Bargain Basket Marco Island Site Development Plans

REVIEWED
MIU BB 11/26/24

SUBMITTAL
SDP

Reviewed for code compliance
M Holden
12/18/2024 12:20:41 PM

SITE PLAN

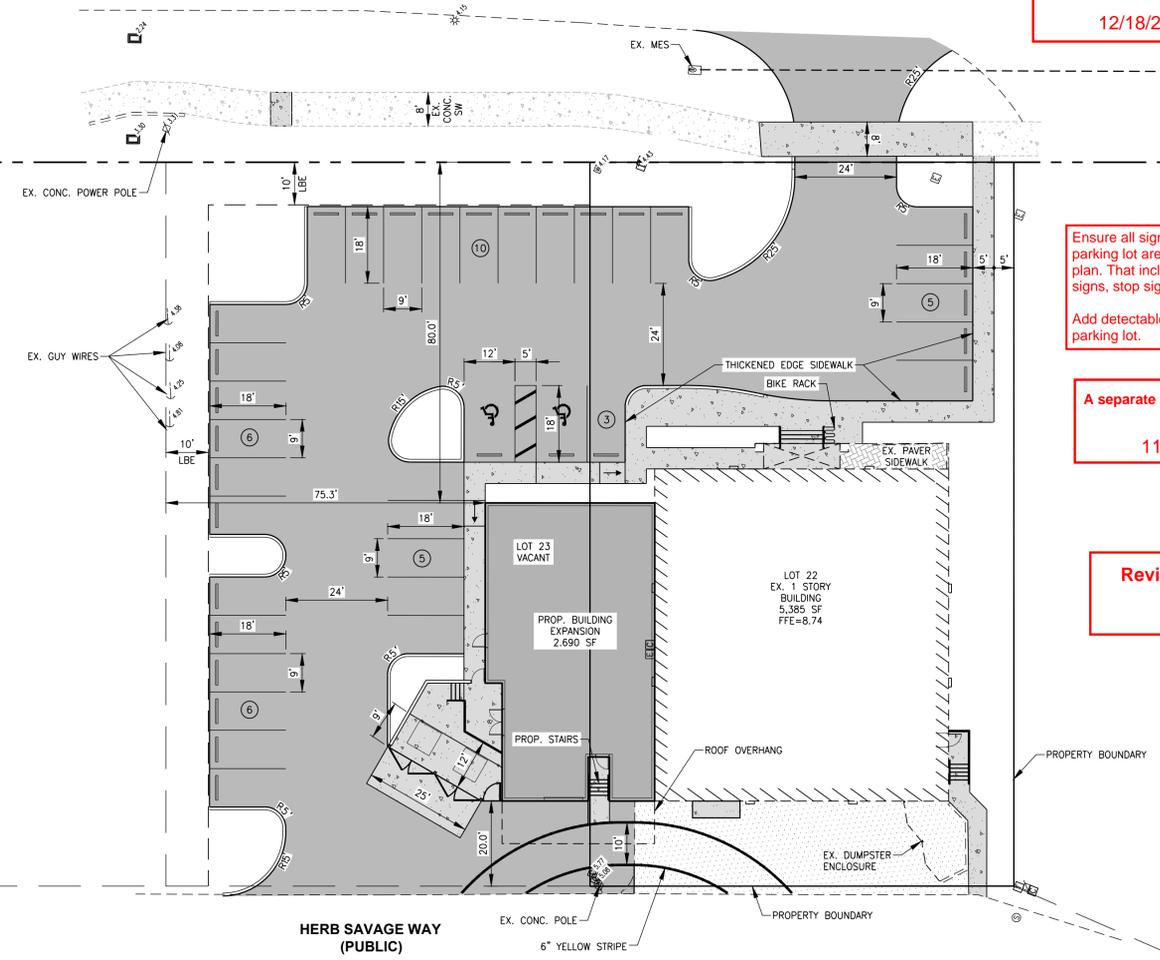
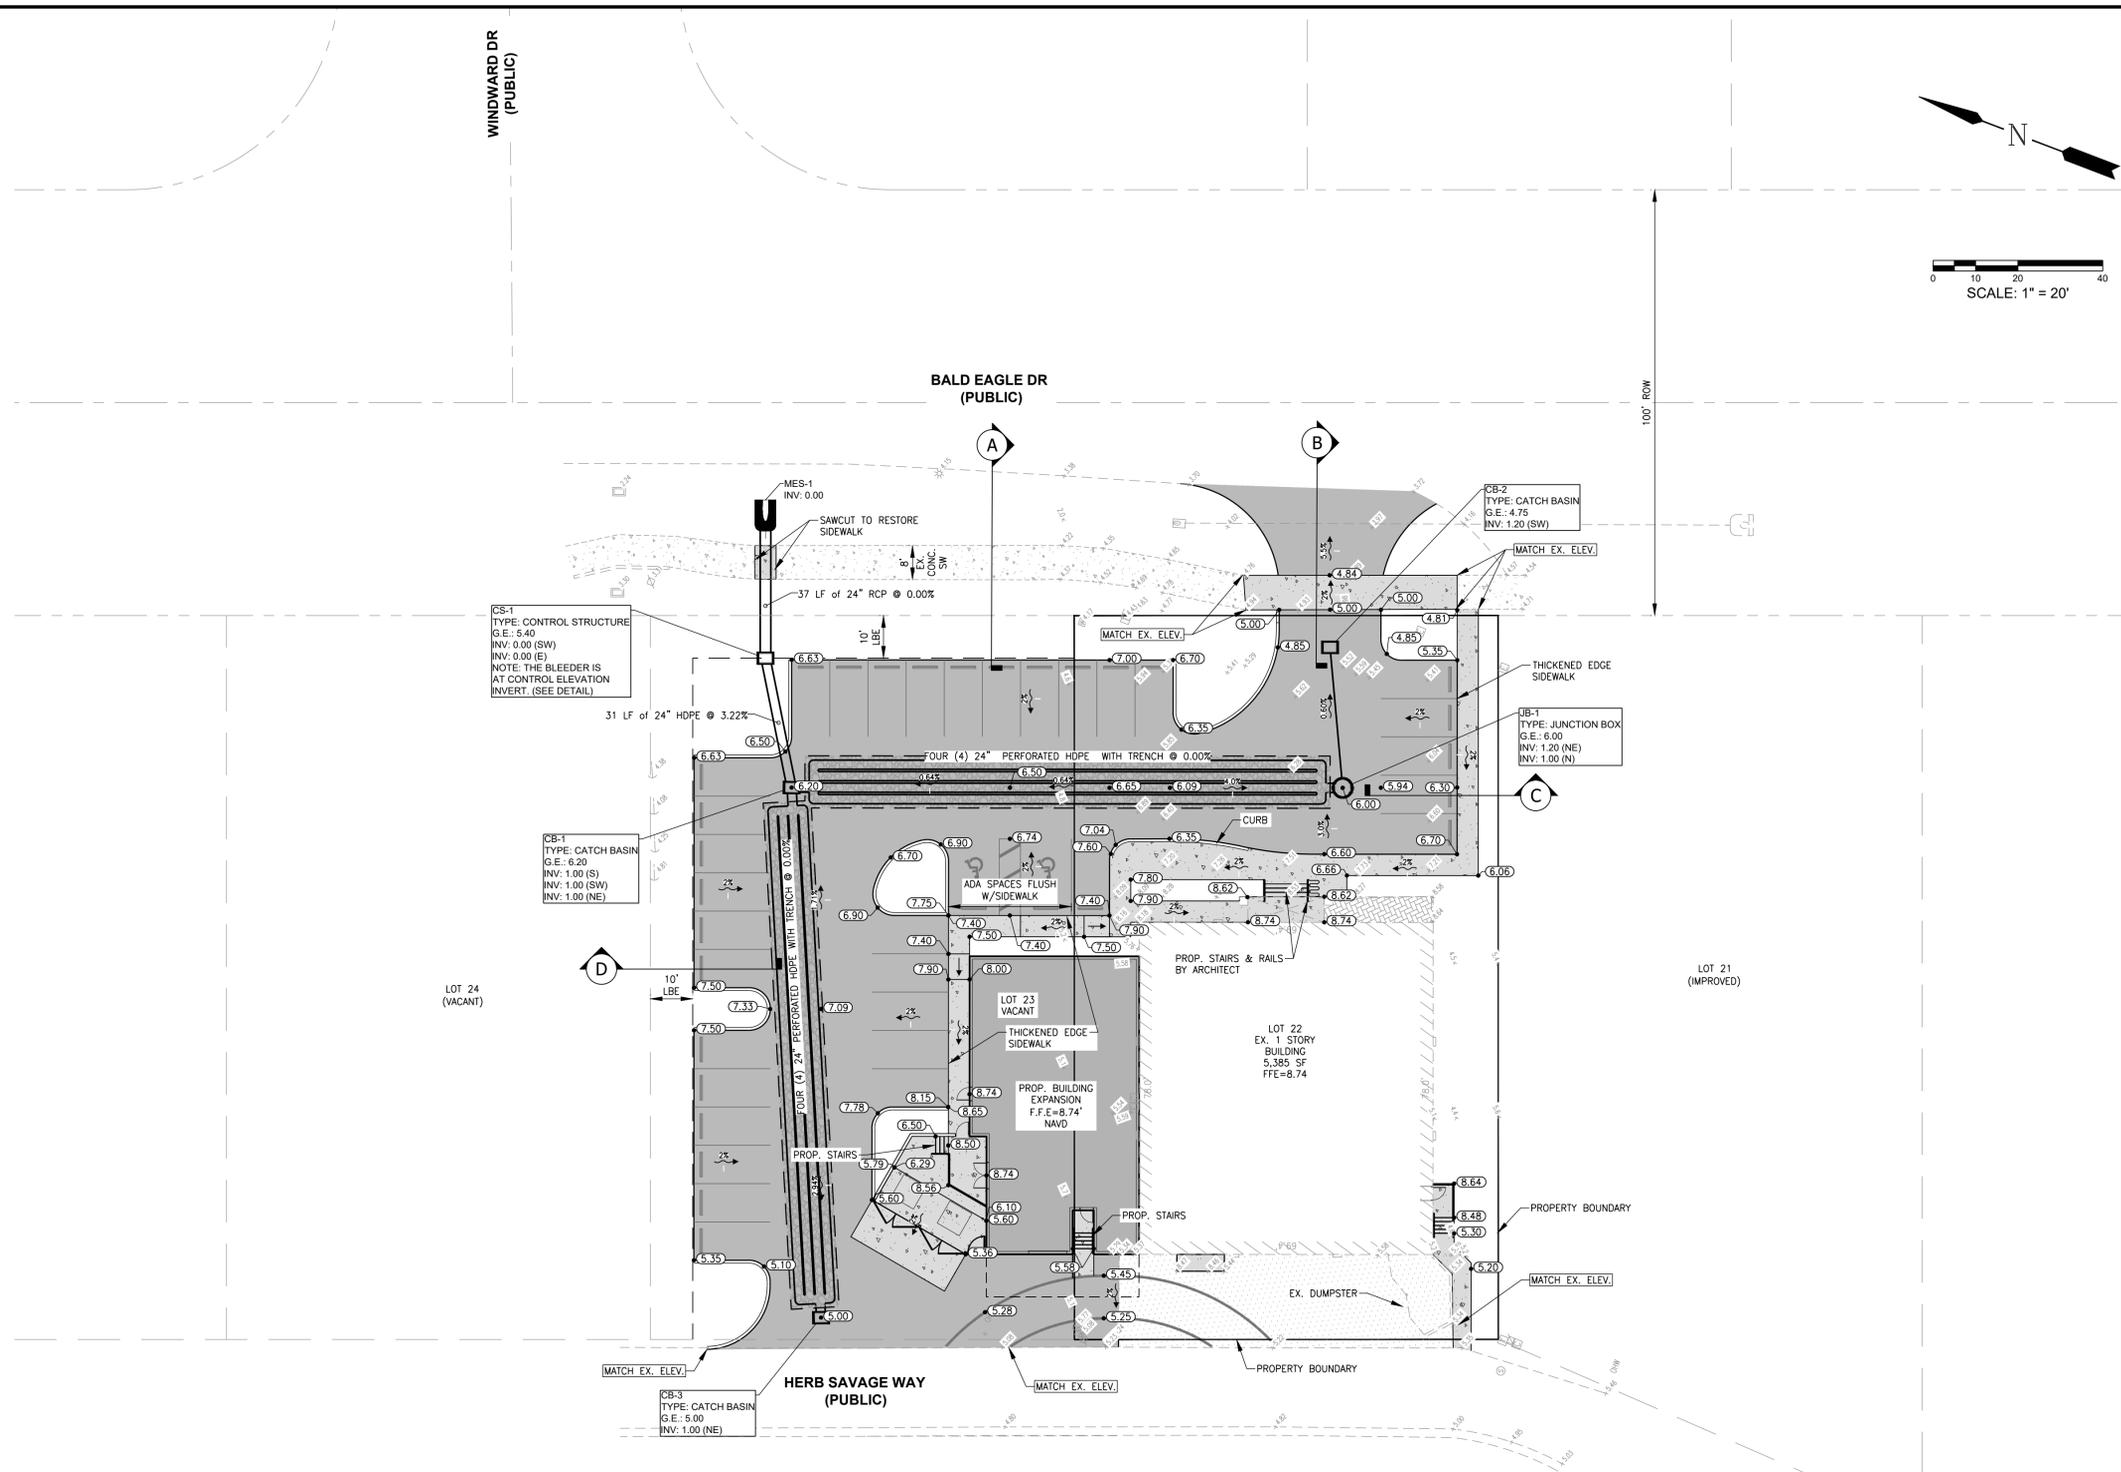
Provide comprehensive drainage calculations, including water quality and attenuation aspects for the current and proposed surface water management system
11/14/2024 3:03:28 PM

Provide an additional 50% Water Quality Volume to meet enhanced treatment capacity standards.
11/14/24

Ensure all signage and pavement markings within the parking lot are clearly and appropriately placed in the plan. That includes directional arrows, do not enter signs, stop signs, etc.
Add detectable warning surfaces at entrances to the parking lot.

A separate RW permit is required for any work within the right-of-way.
11/14/2024 2:56:46 PM
